PROJECT NAME: STERLING HALL SCHOOL – PHASE 1 MASTER PLAN ADDITION

PROJECT No.: 00036-010-E-001

DATE: 2026-07-22

ADDENDUM No.: E01

9 EXTERIOR LIGHT CONCRETE BASE

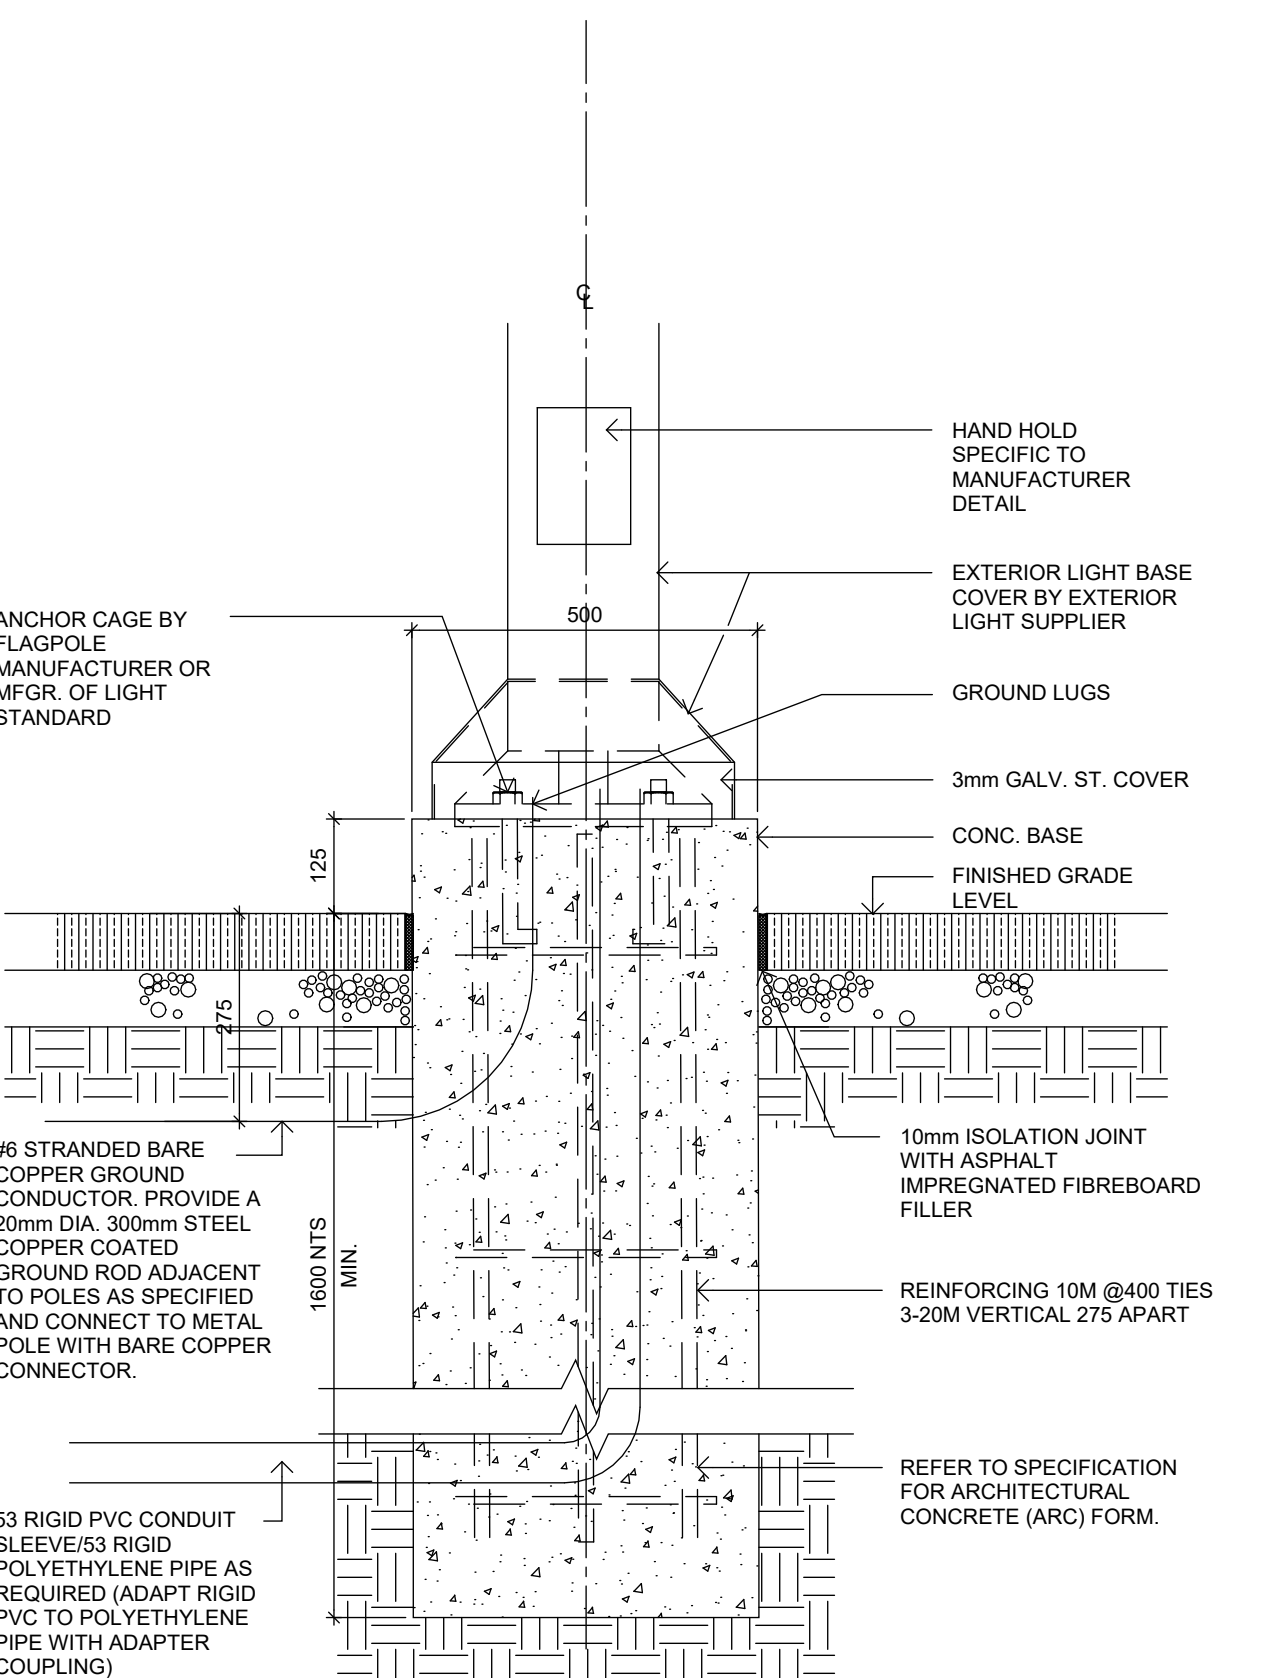
2.1.3 E-003: Revise lighting standard base detail.

scale: N.T.S.  
date: XX/XX/2X  
drawn: RLJG  
checked by: Checker  
project number: 00036.010.E001  
drawing number: E-004  
Revision: 8

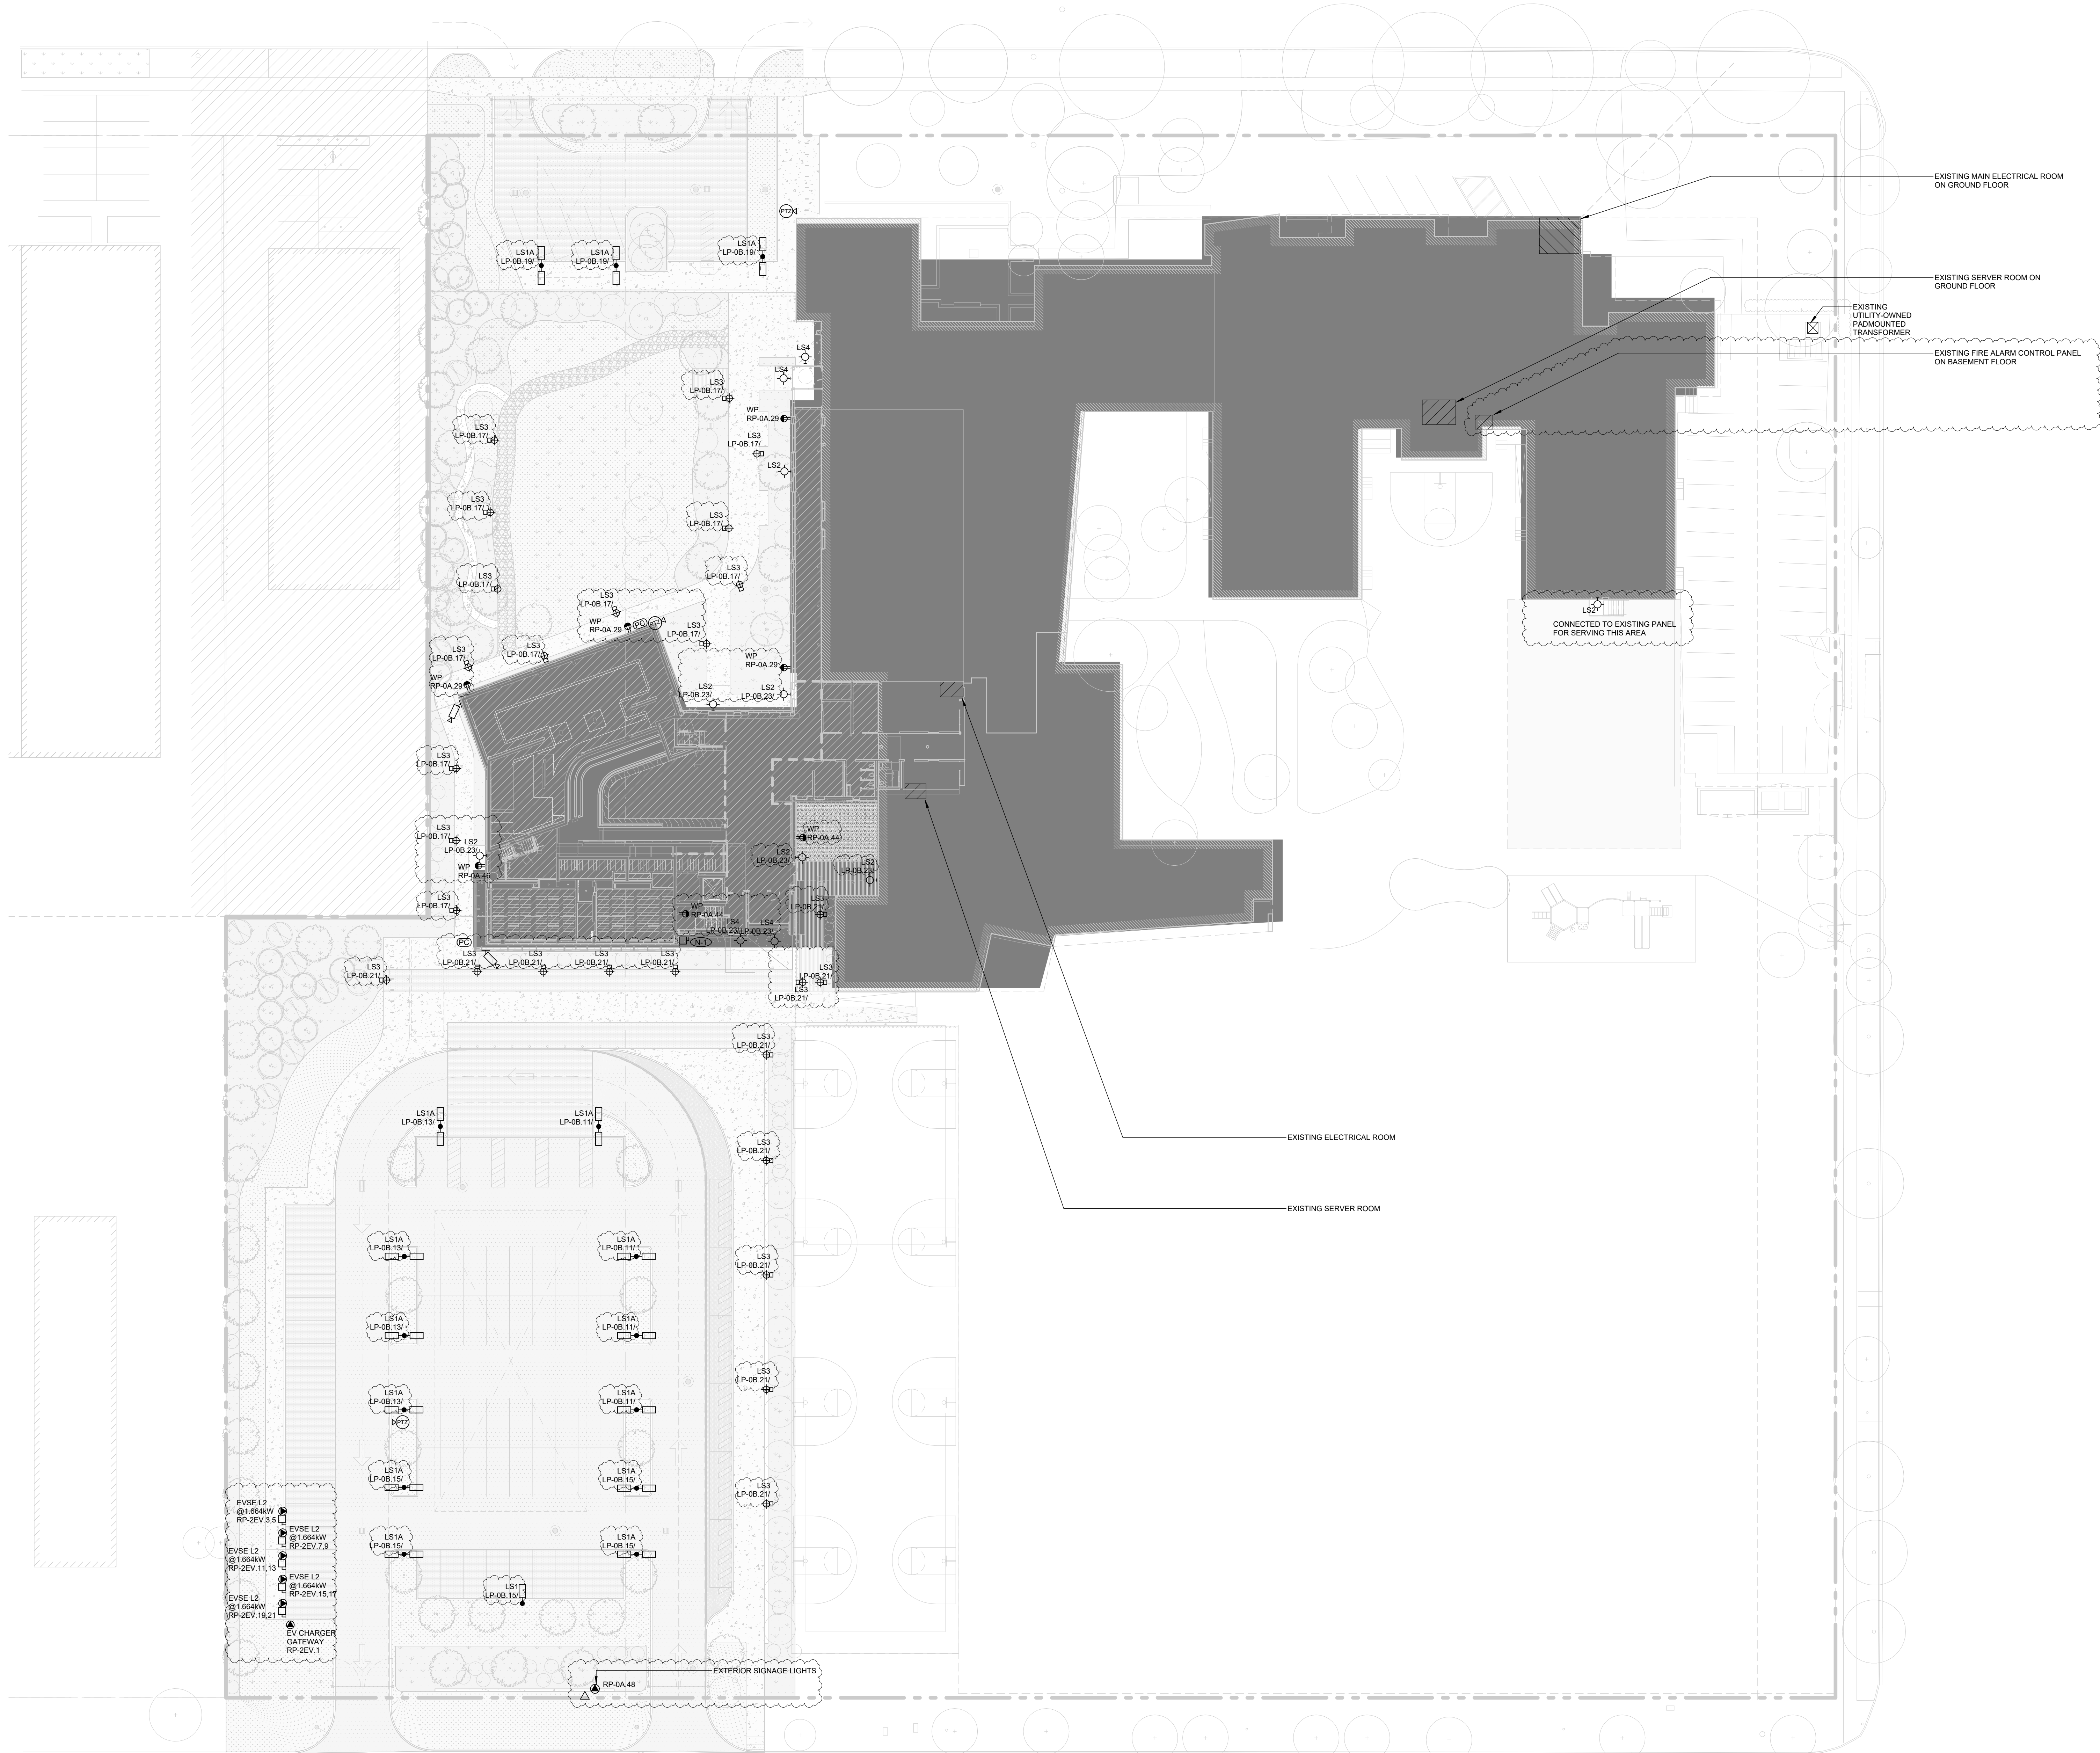
2.1.4 E-004: Add grounding riser detail.

scale: N.T.S.  
date: XX/XX/2X  
drawn: RLJG  
checked by: Checker  
project number: 00036.010.E001  
drawing number: E-200  
Revision: 8

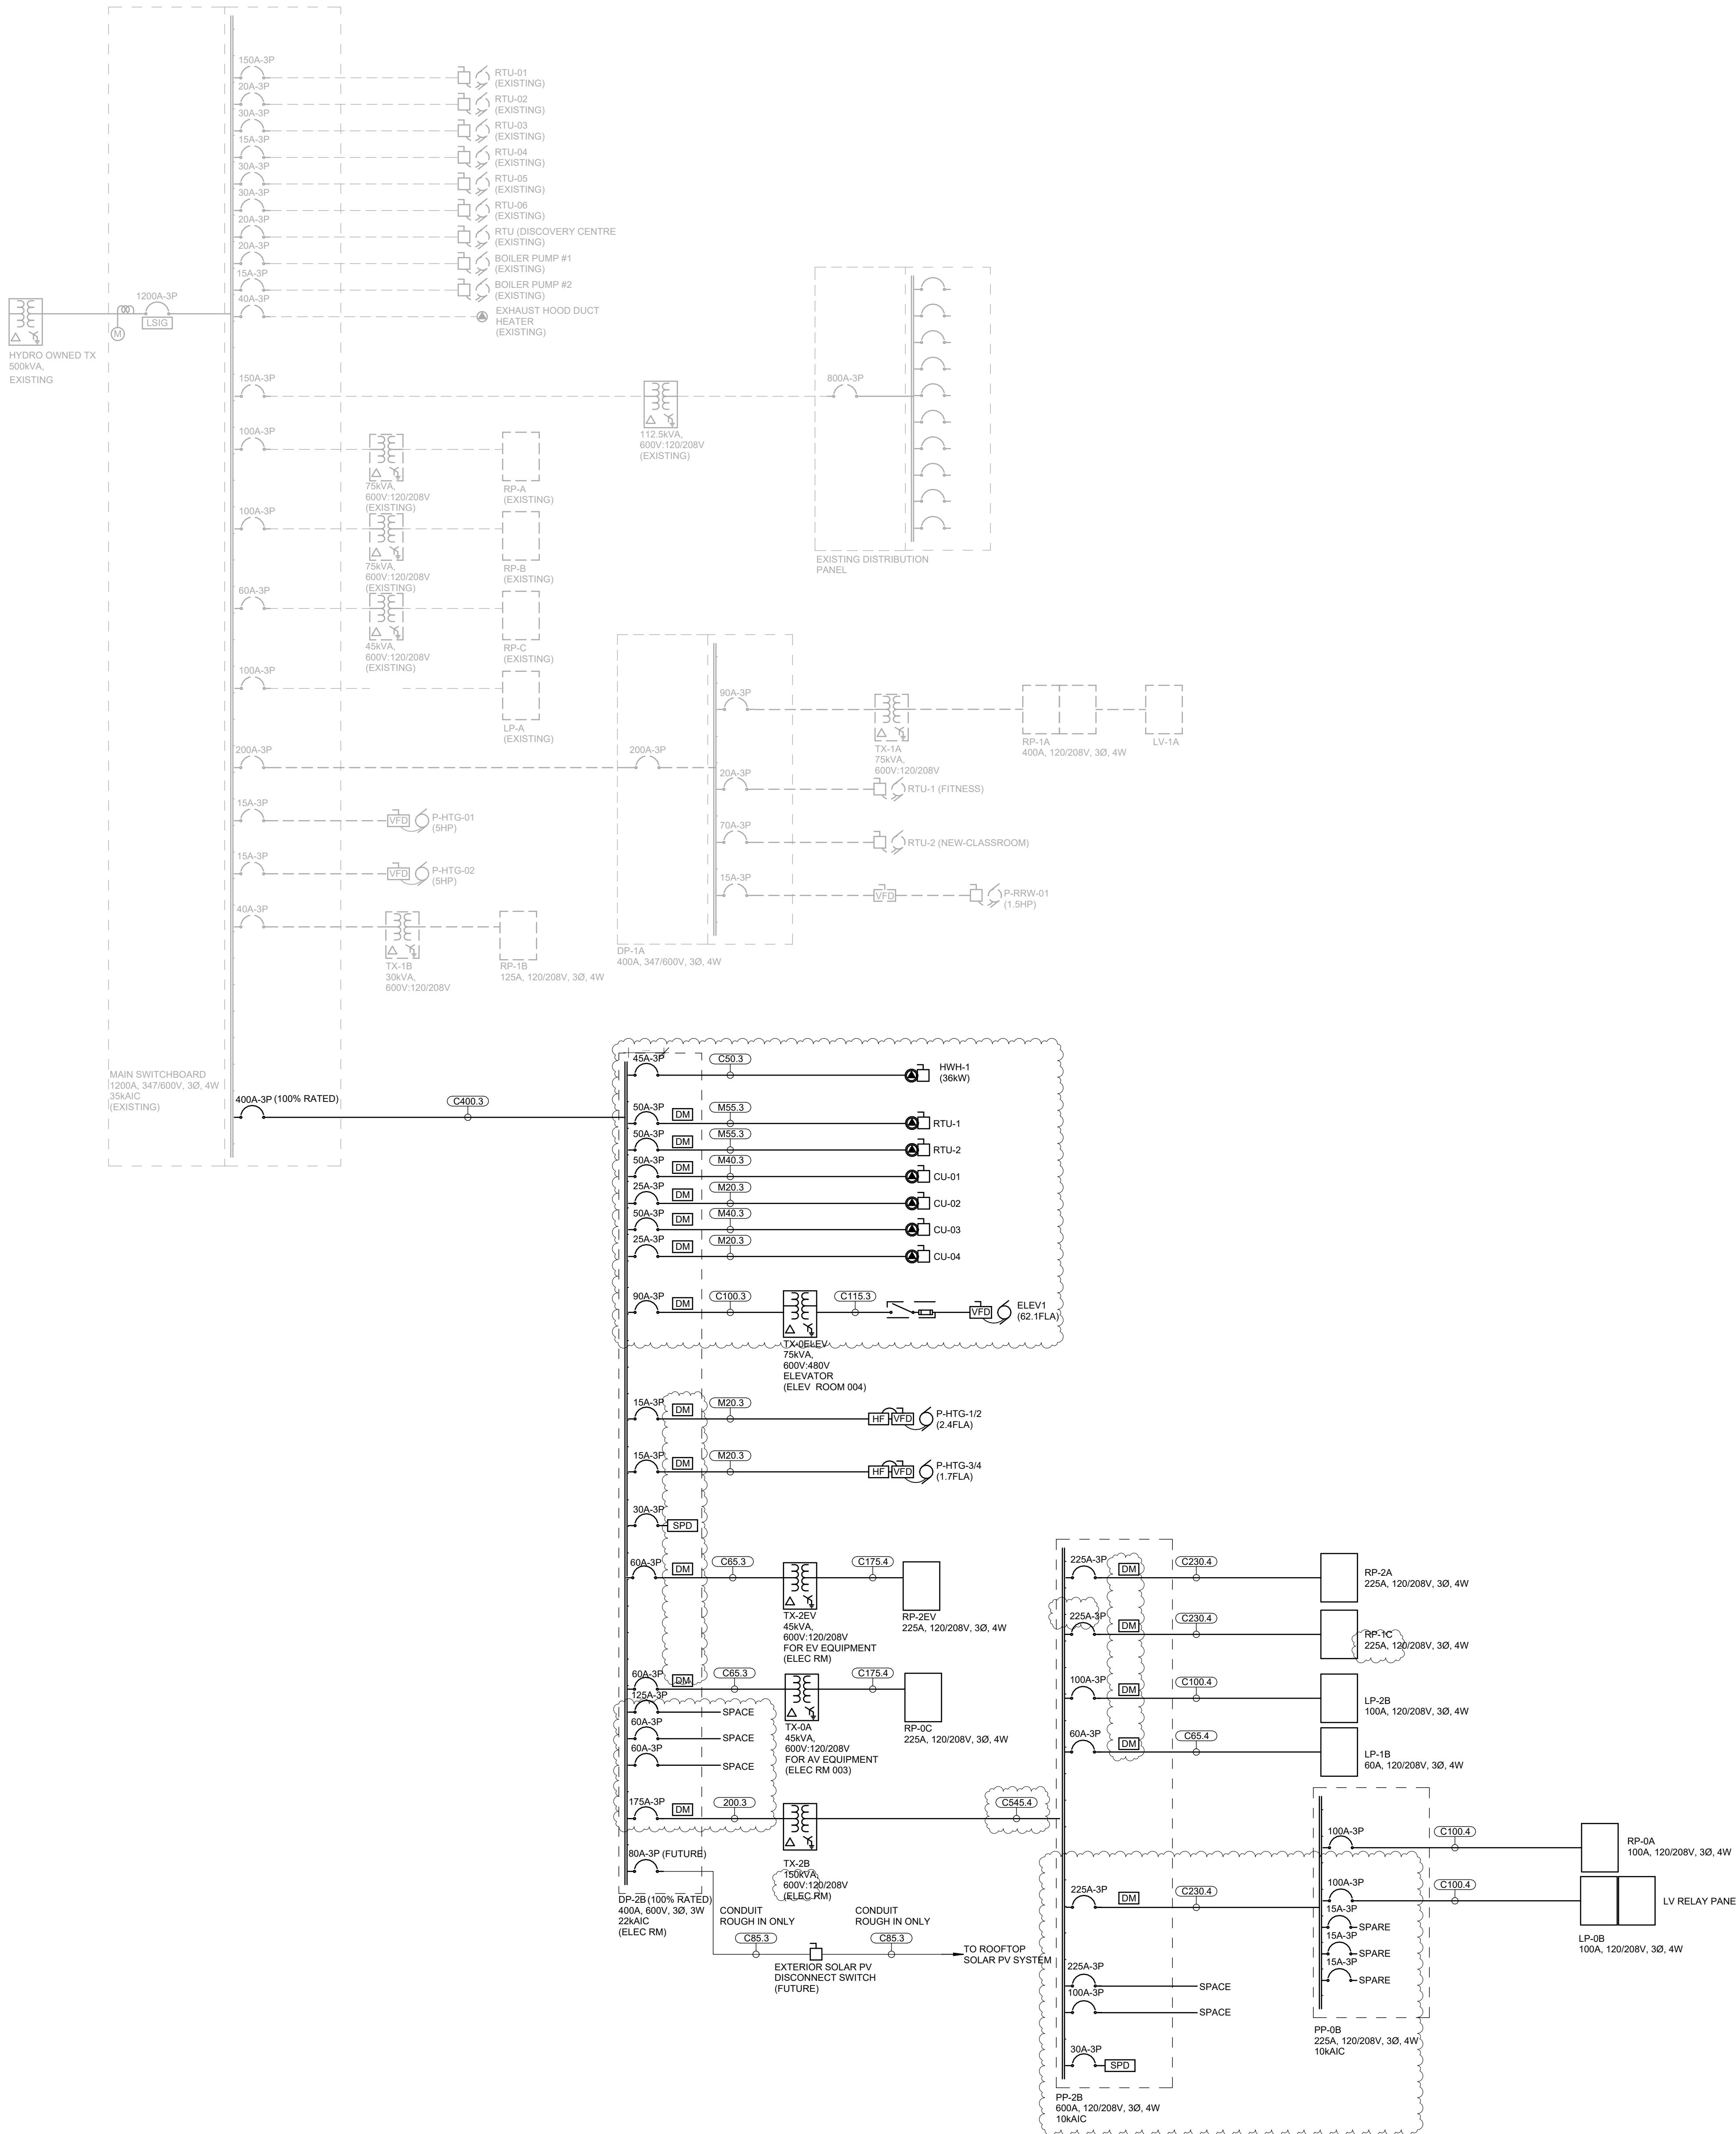
- 2.1.6 E-200: Revise electrical distribution equipment and feeders.
- 2.1.7 E-201: Add fire alarm DGP and revise fire alarm riser. Security riser clarifications.
